MILITARY SPECIFICATION

MODULES, STANDARD ELECTRONIC

GATE, NAND, DIGITAL, KEY CODE CHH

This amendment forms a part of Military Specification MIL-M-28787/293(EC), dated 7 March 1980, and is approved for use by the Naval Electronic Systems Command, Department of the Navy, and is available for use by all Departments and Agencies of the Department of Defense.

FIGURE 6. V_{OUT} (low-loaded) test circuit for table IV.

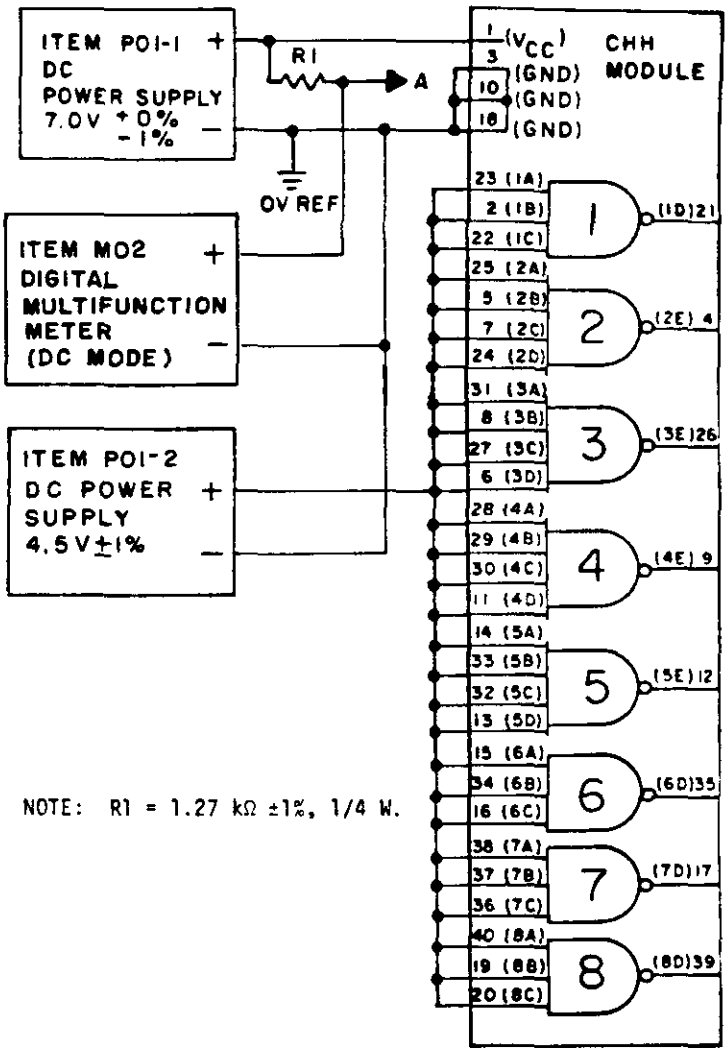
FIGURE 6: Delete and substitute new figure 6 as printed on page 2 of this amendment.

FIGURE 10. Input clamp diode voltage test circuit for table VIII.

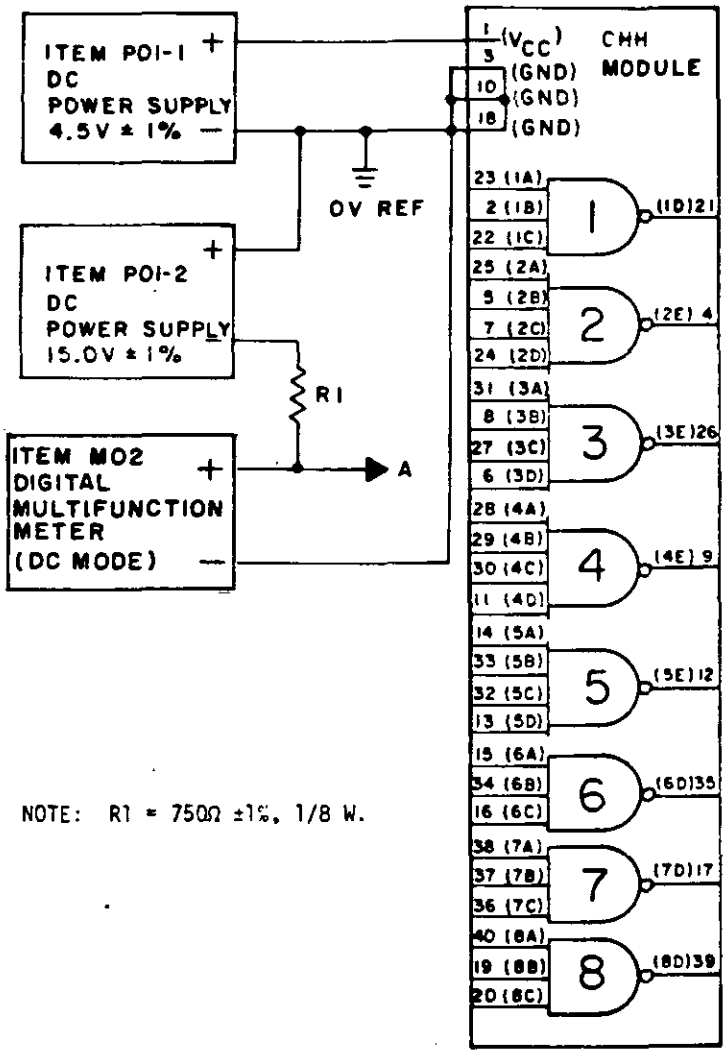
FIGURE 10: Delete and substitute new figure 10 as printed on page 3 of this amendment.

FIGURE 11. Static output voltage (low-level and high-level) test circuit for tables IX and X.

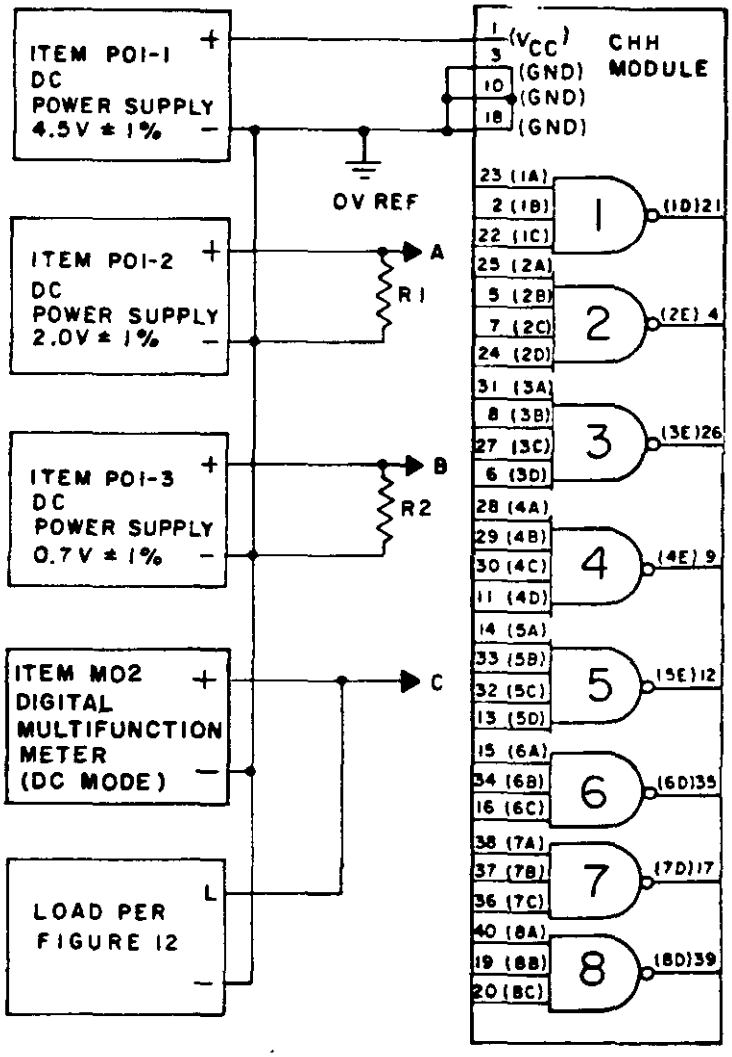
FIGURE 11: Delete and substitute new figure 11 as printed on page 4 of this amendment.

FIGURE 17. Transition time and propagation delay time test circuit for table XV.

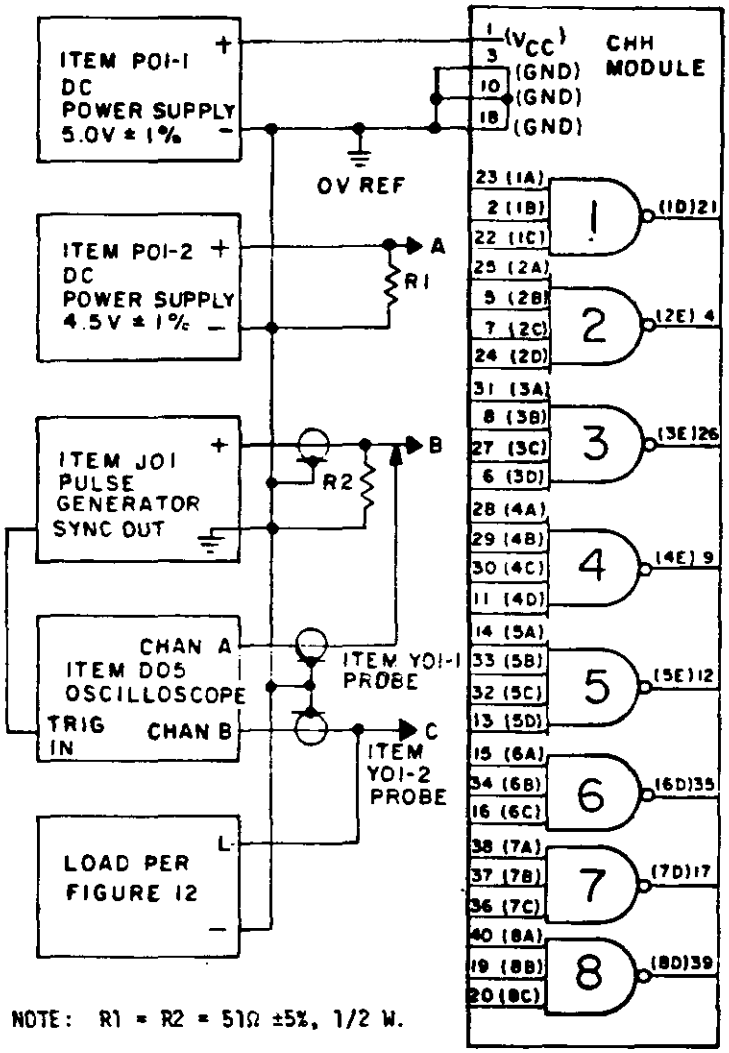
FIGURE 17: Delete and substitute new figure 17 as printed on page 5 of this amendment.

FIGURE 23. Power supply transient amplitude test circuit for table XVIII.

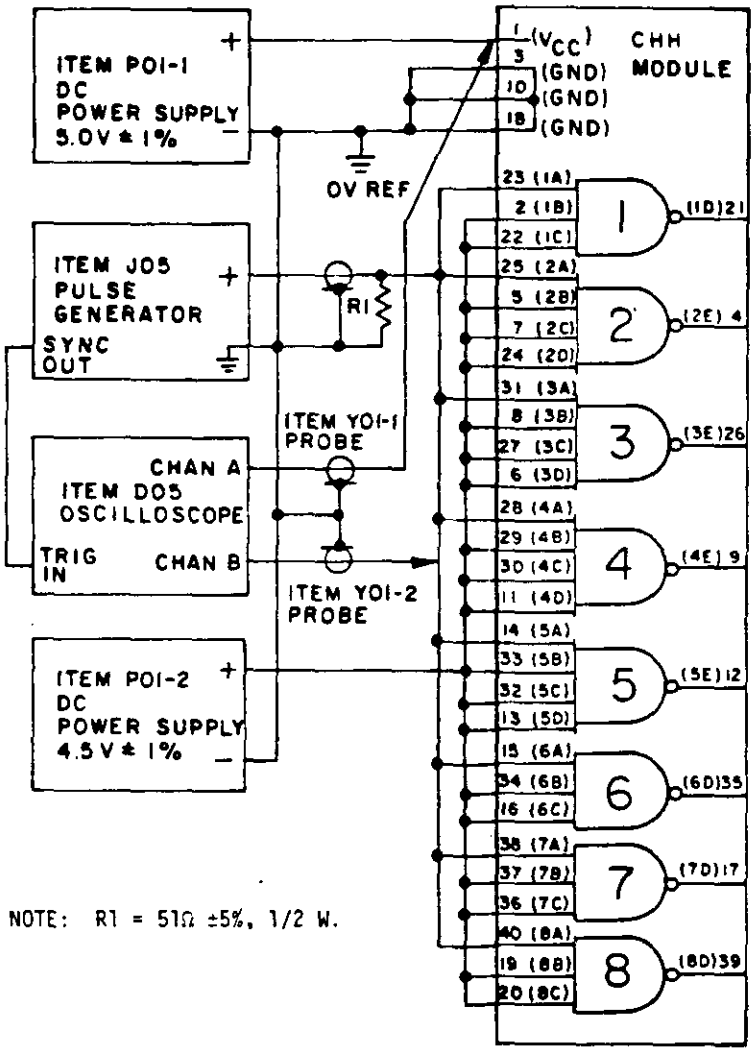
FIGURE 23: Delete and substitute new figure 23 as printed on page 6 of this amendment.
